**MEETING OF THE DESIGN REVIEW BOARD
MORRIS N. BROAD COMMUNITY CENTER
1175 95TH STREET
BAY HARBOR ISLANDS, FL 33154**

REVISION # 1 REVISION DATE: 07/18/23

Subject: Site Development Plan Application - Revision
Proposed New 9 DU Multifamily Residential Complex
Revisions to Approved Site Development Plan
1055 93rd Street
Bay Harbor Islands Acct. No. SPR22-000026
MMPA Acct. No. 01-0702-1144

Revision to Approved Planning and Zoning Board Submission

Sheet A-41, Building Section

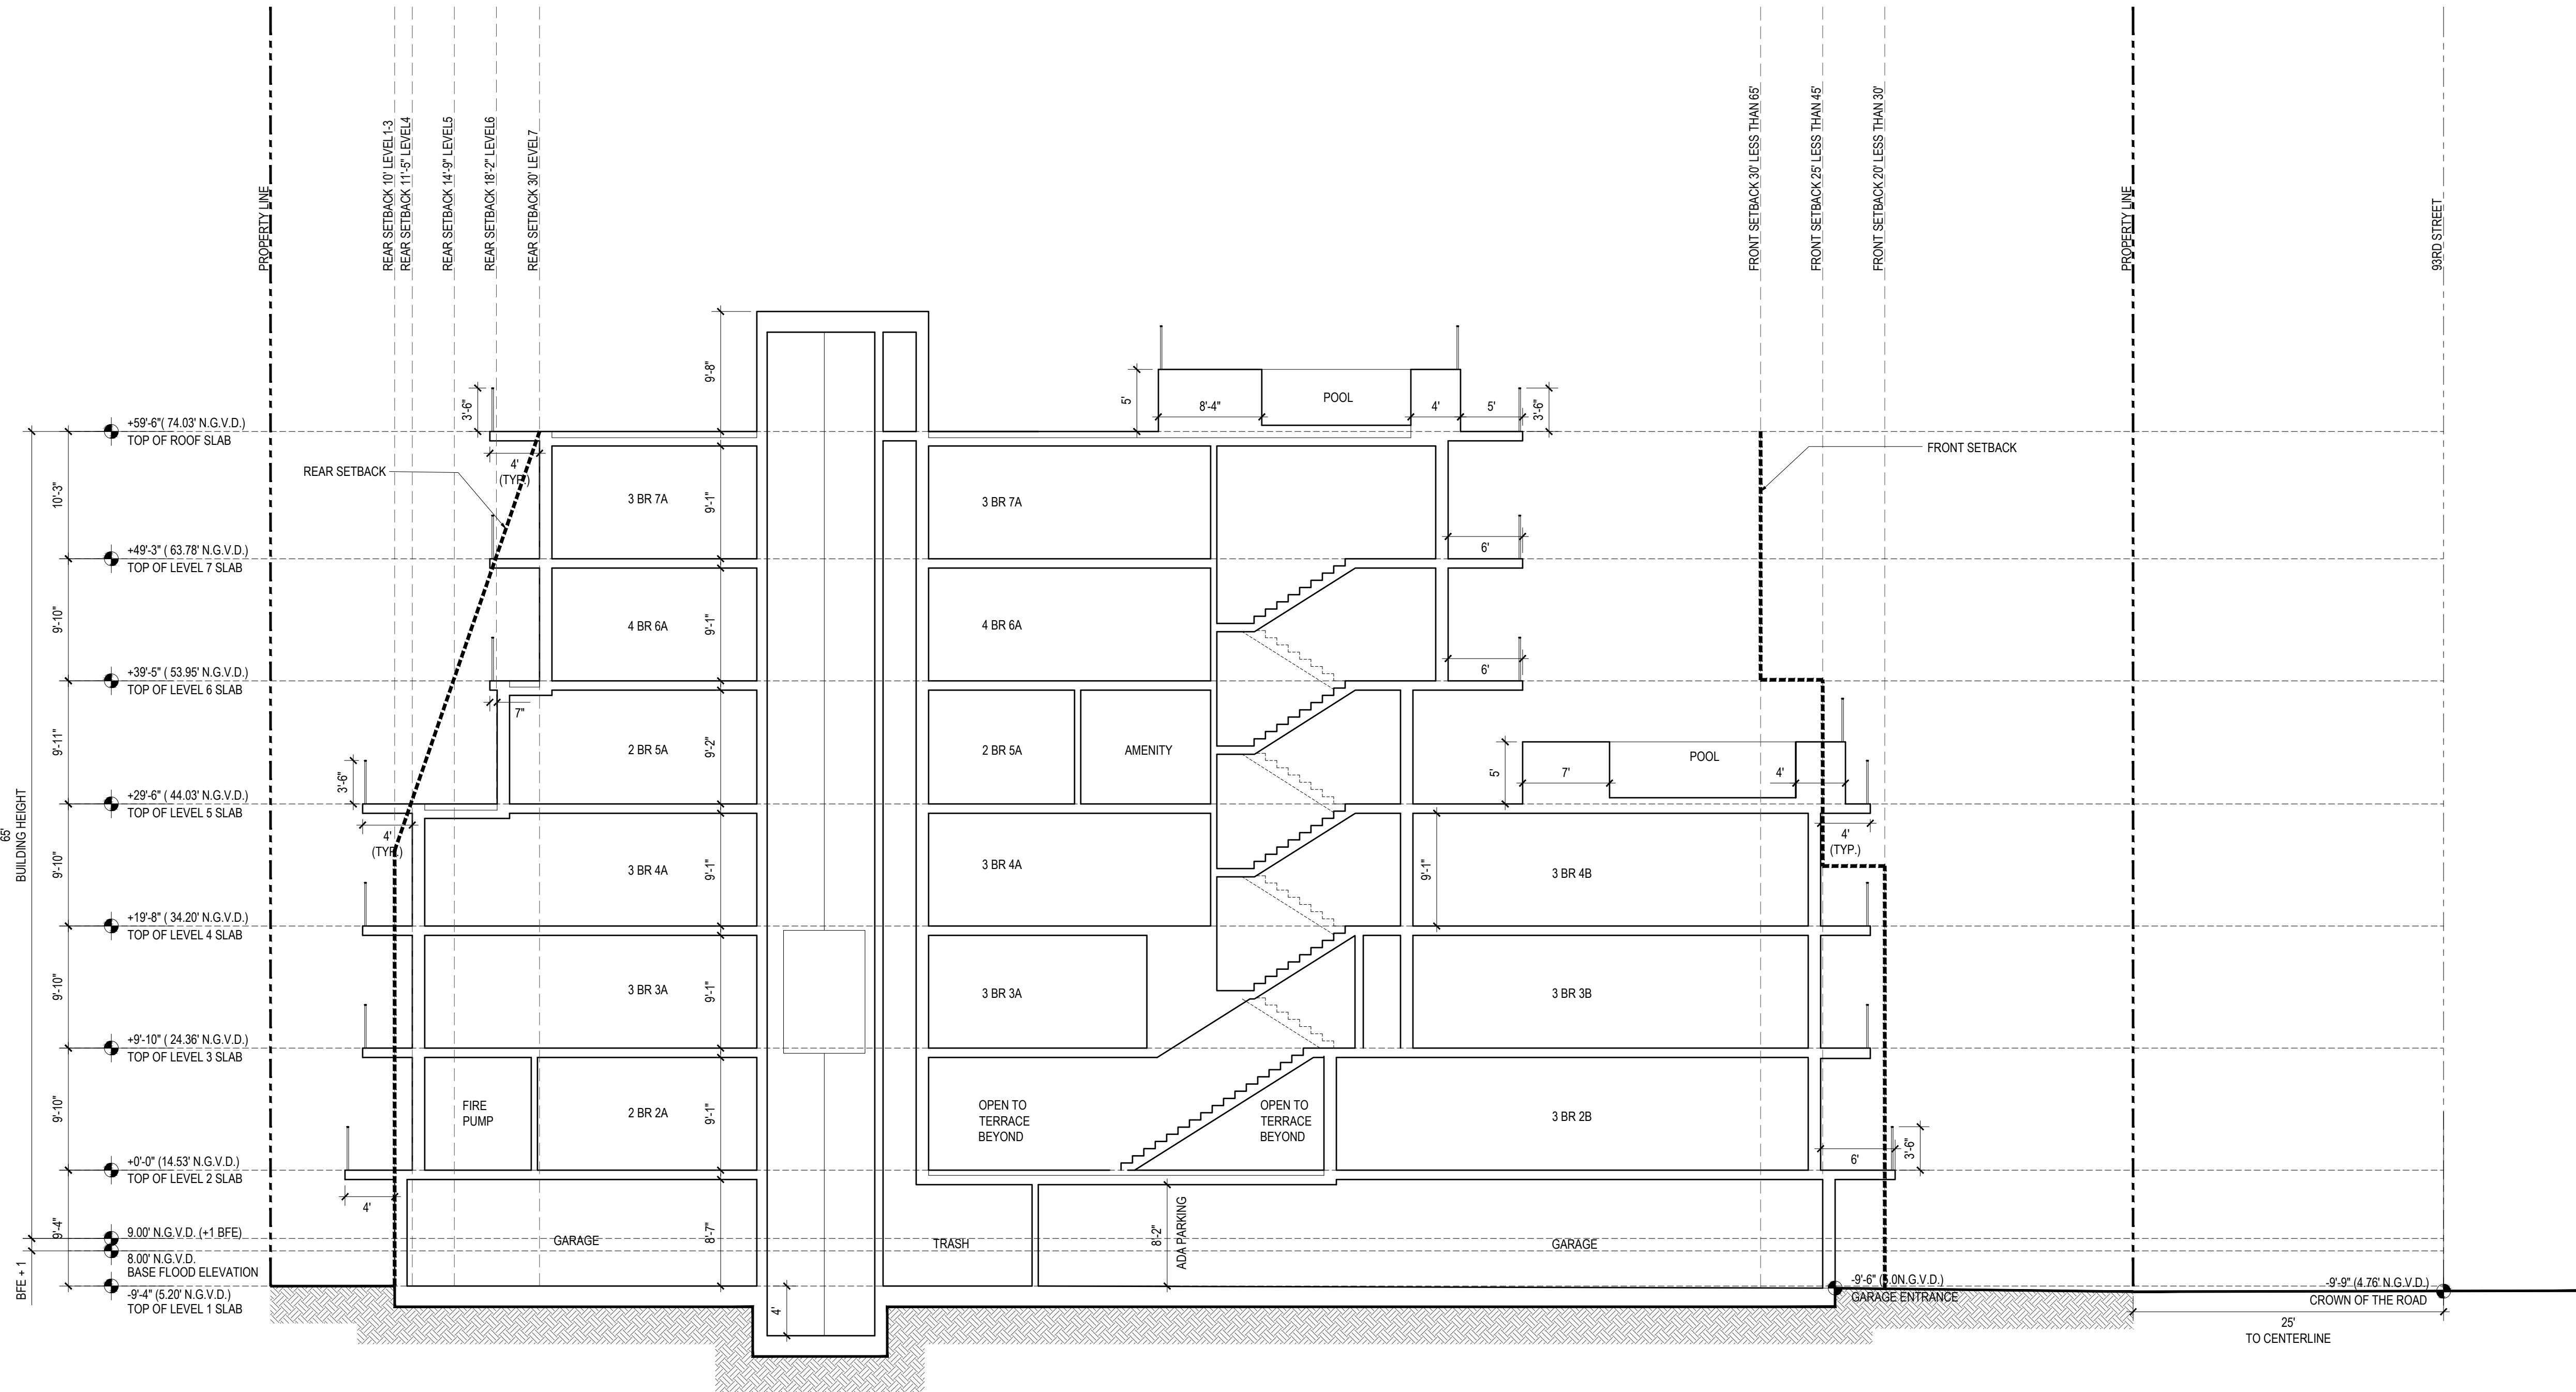
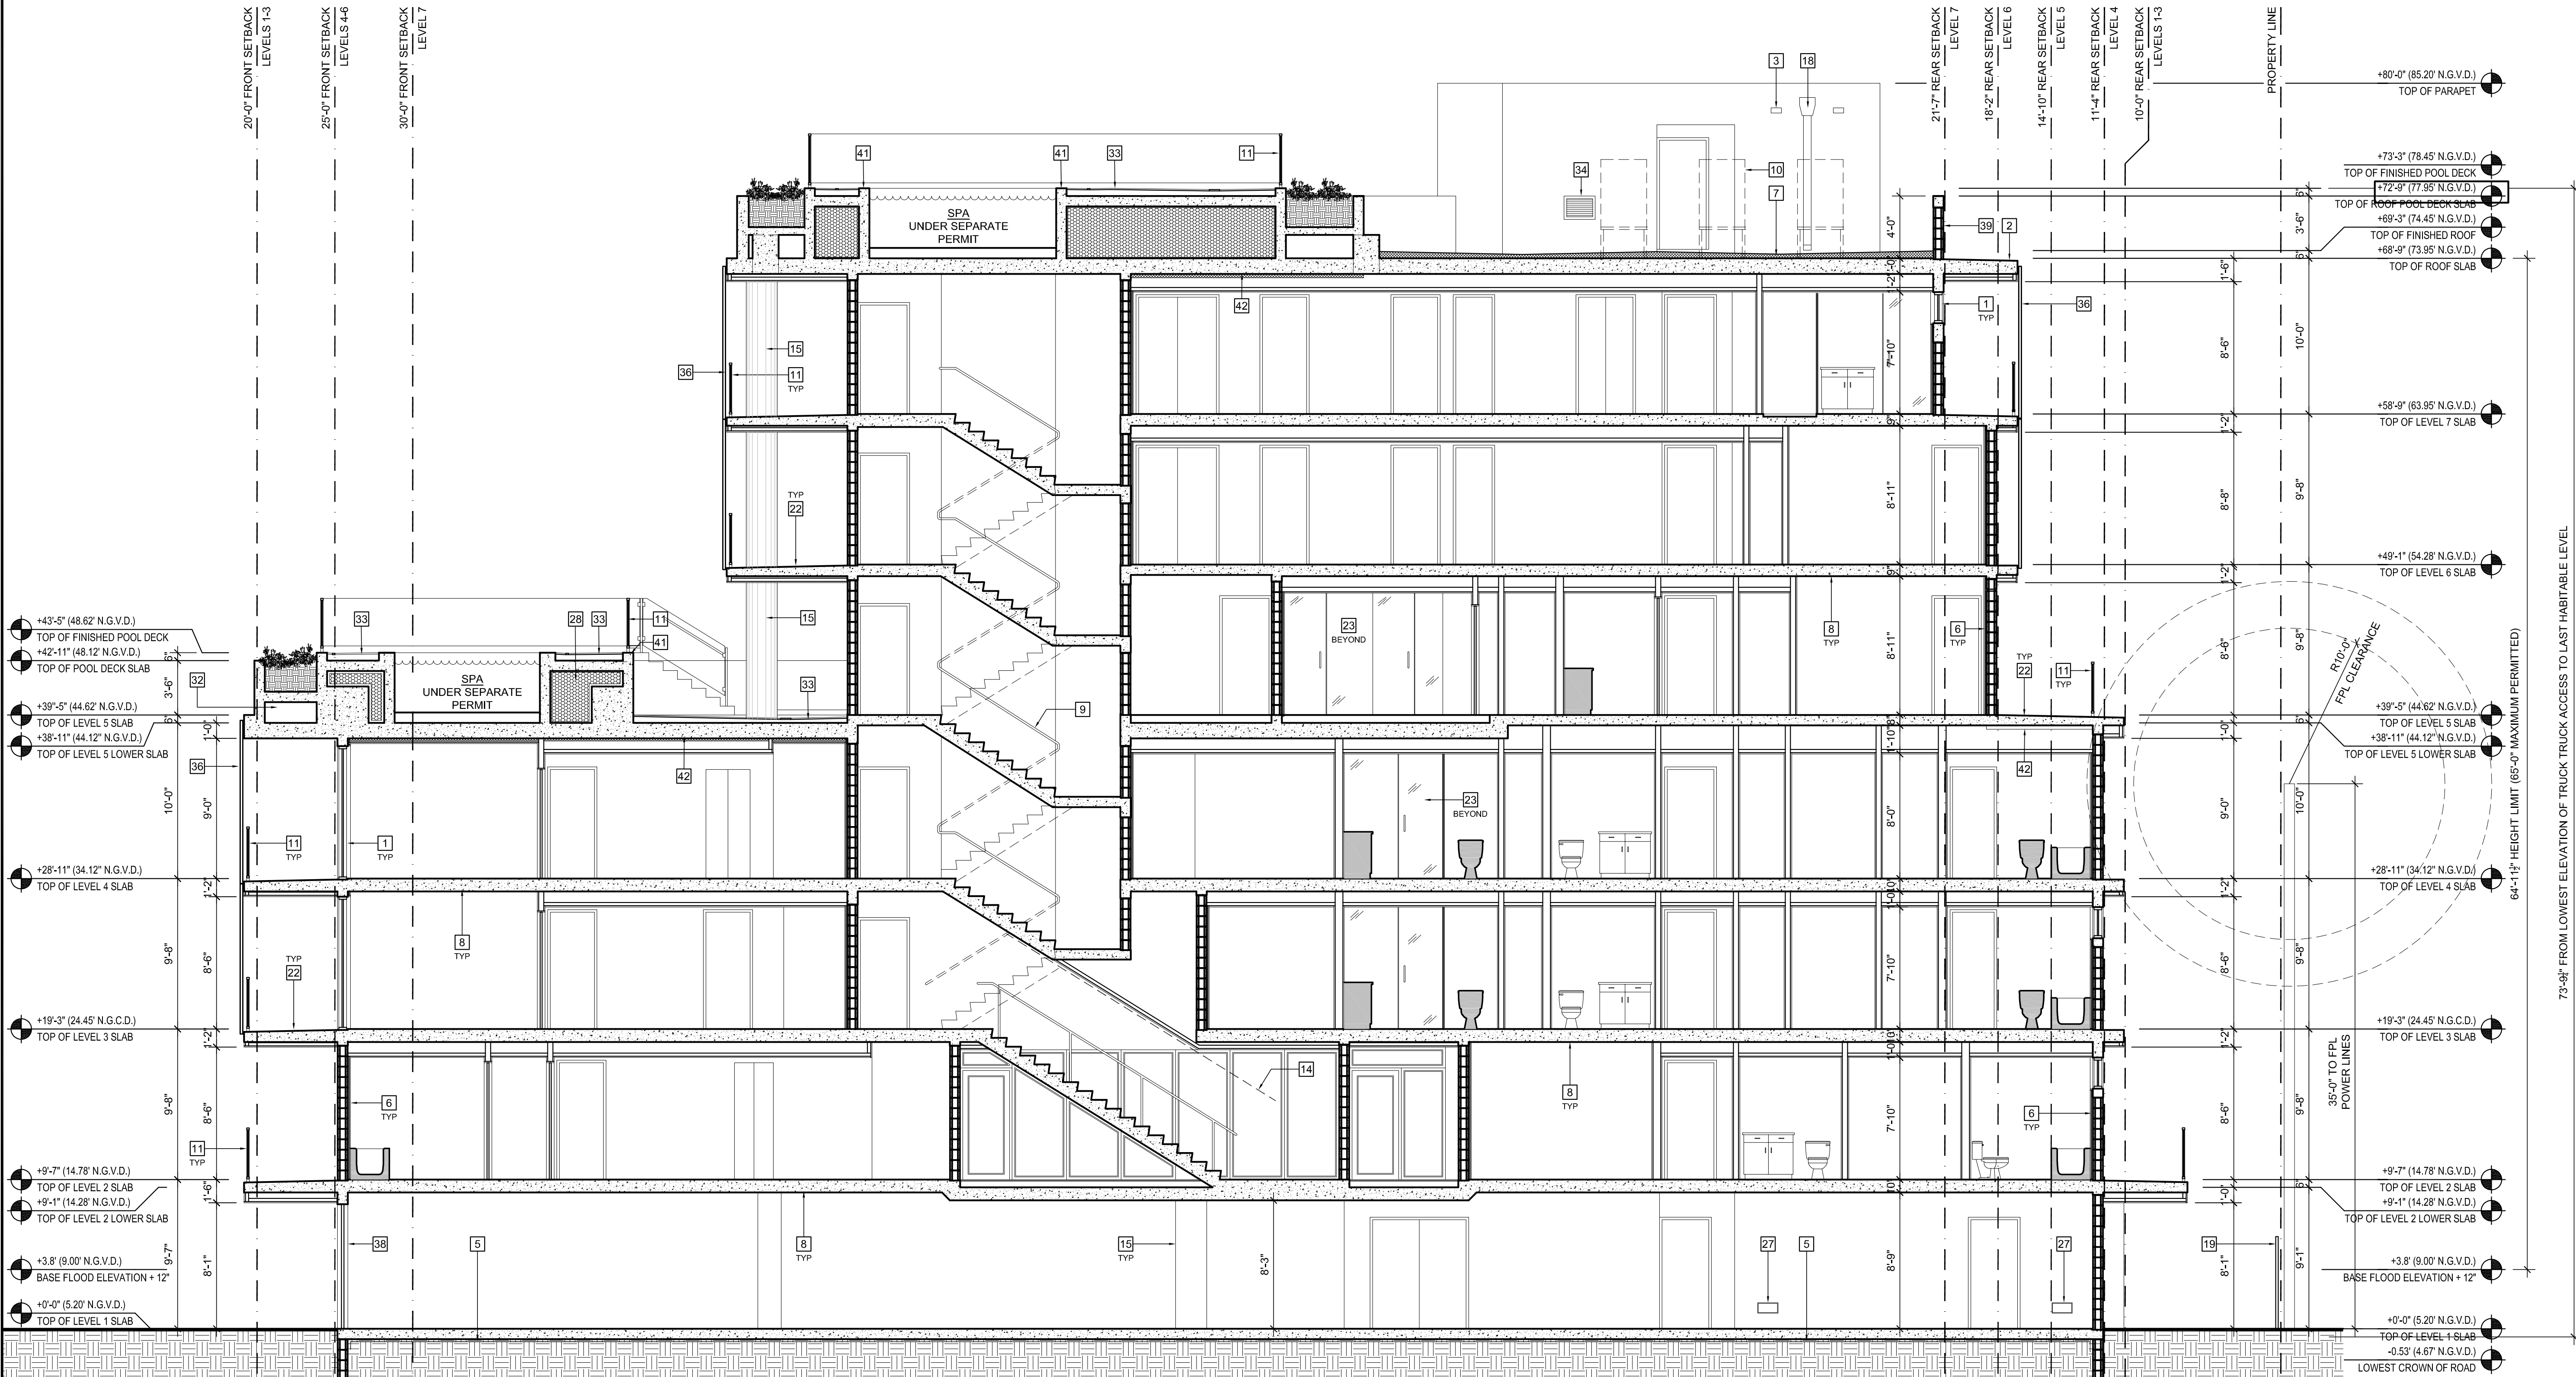
1. Modifications to the rear of the building to remove the north facing balconies and associated louvers on Levels 3 and 4 and to reduce the balcony on Level 5 due to the proximity to the FPL power lines that are running along the rear property line
2. Section updated to reflect plan and elevation changes due to unit layout modifications and structural coordination
